PUBLIC INTEREST REVIEW FOR GROUND WATER APPLICATIONS

SUBJECT: Application G- 15943 Supersedes review of May 12, 2003
Date of Review(s)

A. GENERAL INFORMATION: Applicant's Name: Mary Blandau County: Jackson

A1. Applicant(s) seek(s) 0.089 cfs from 1 well(s) in the Rogue Basin,
Constance Creek subbasin Quad Map: Boswell Mountain

35S - 02W - 13ab
G-15943 Mary Blandau
Boswell Mountain Quad
Scale 1:24,000

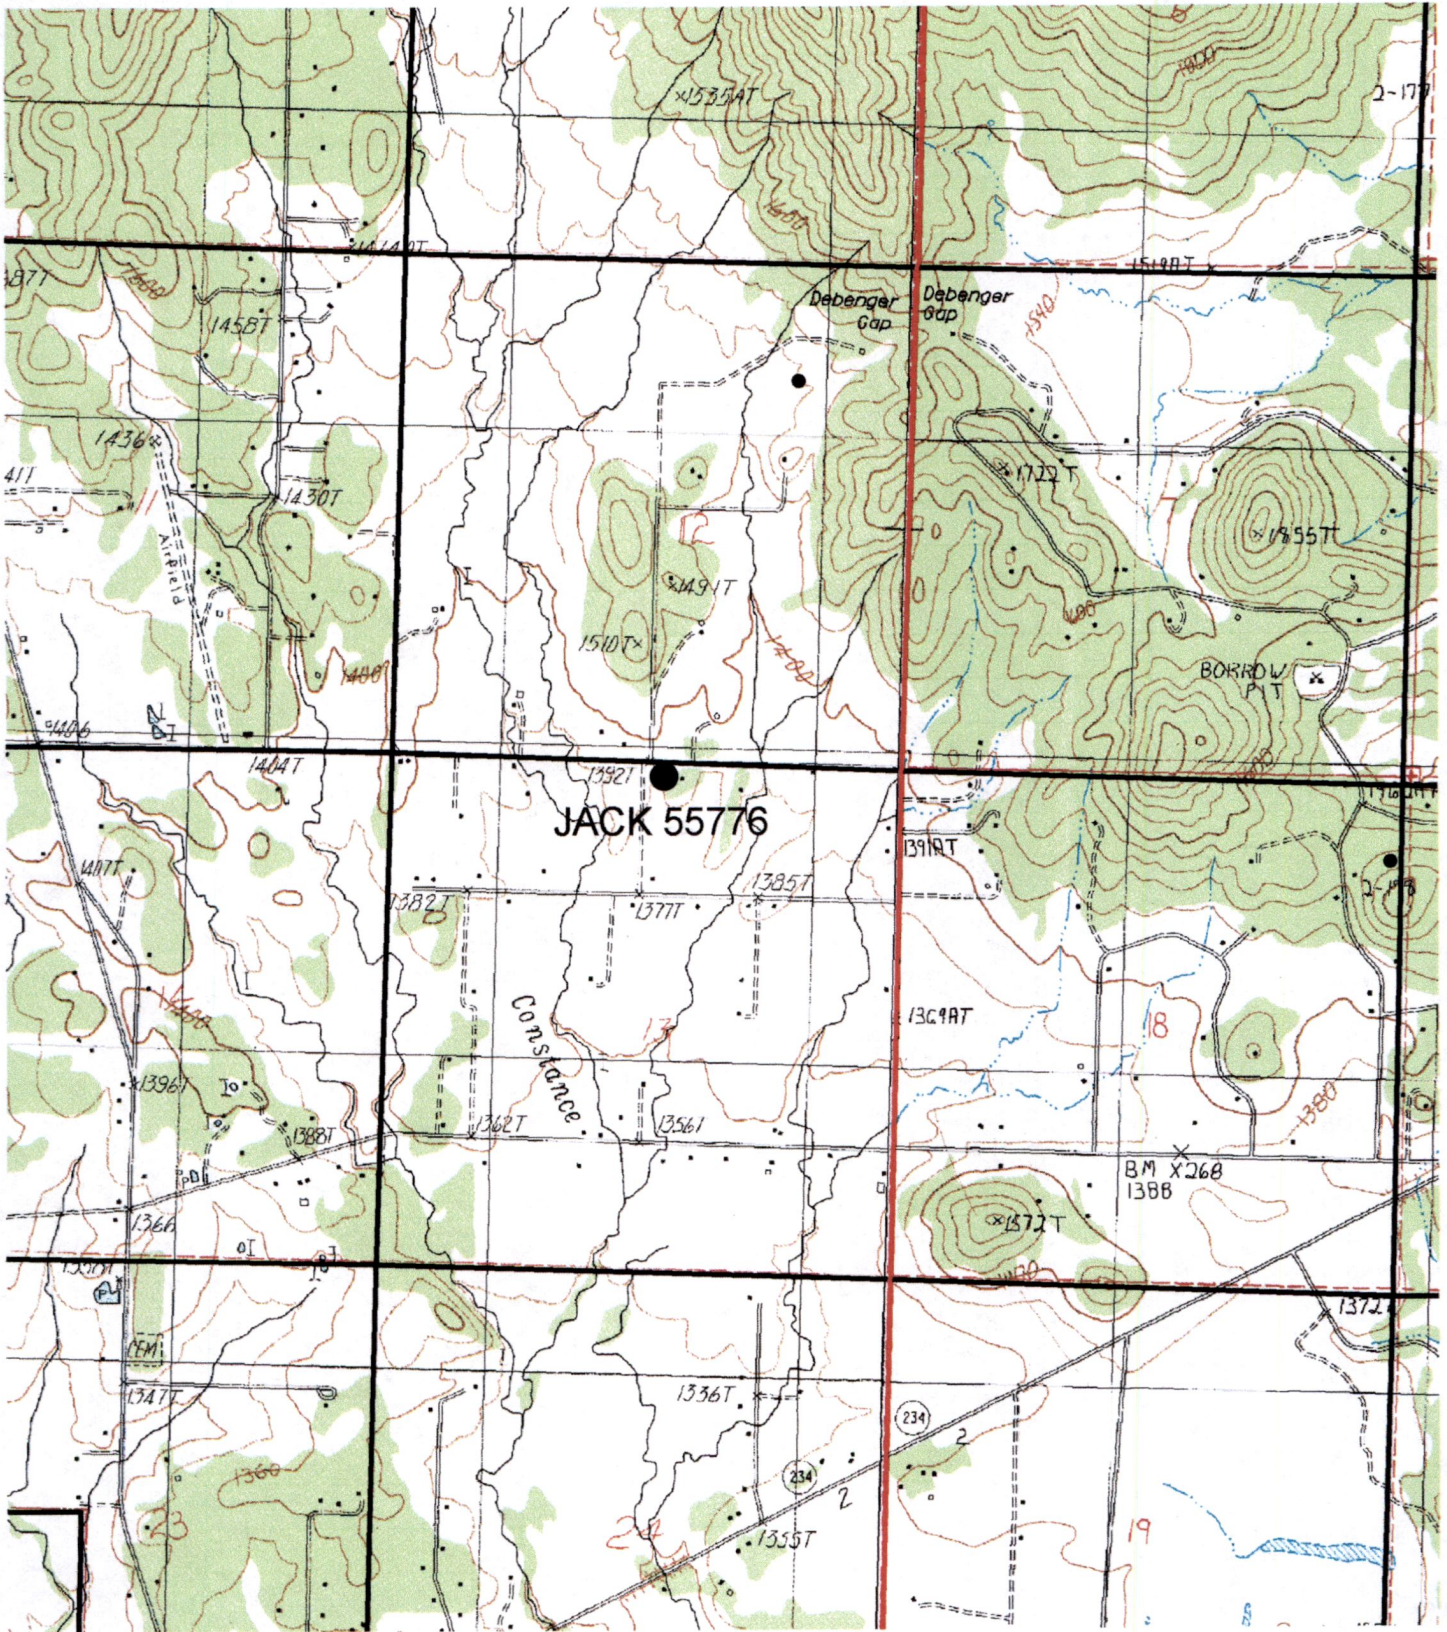
The bedrock in the area is composed of upper Eocene siltstone, mudstone, sandstone, conglomerate, and coal of the Payne Cliffs Formation. The original sediments were river deposited with the provenance believed to be local. The main stem of Constance Creek west of the site has deposited older quaternary alluvium. The subject well log notes "blue claystone" from 2 to 82 feet bgs. Overlying the bedrock are 2 feet of "black soil". Well logs in the vicinity of the subject site suggest that the depth to bedrock is approximately 2 to 10 feet. Ground water appears to be encountered in fractures ranging from 30 to 150 feet bgs.

Based on the reported well yields, the area appears to be good for domestic ground water development. OWRD has permitted some wells in the area for irrigation rights. However, sustainable well yields at the reported rates (on well logs) in fractured rock of the Payne Cliffs Formation are suspect based on general knowledge of the area, well interference complaints, and claims by landowners of significant reductions in well yields during summer months and following drought.

Basis for aquifer confinement evaluation: Well yields in area are generally good, suggesting the aquifer is pervasively fractured. Although the aquifer is likely more confined with depth, the water-bearing zones of the applicant's wells are fairly shallow and likely more unconfined than confined.

Basis for aquifer hydraulic connection evaluation: Surface water flow evaluation by staff during 2003-2004 indicated Constance Cr flows dominated by precipitation, with very little, if any, groundwater contribution. Groundwater likely discharges to Rogue River, located approx. 11,000 feet east of the site. Given distance and low primary permeability of aquifer material, and discontinuity of formations, hydraulic connection with the Rogue was not evaluated.

B3. Ground water availability remarks: * Require applicant to install and maintain a properly functioning, totalizing flow meter on each POA.
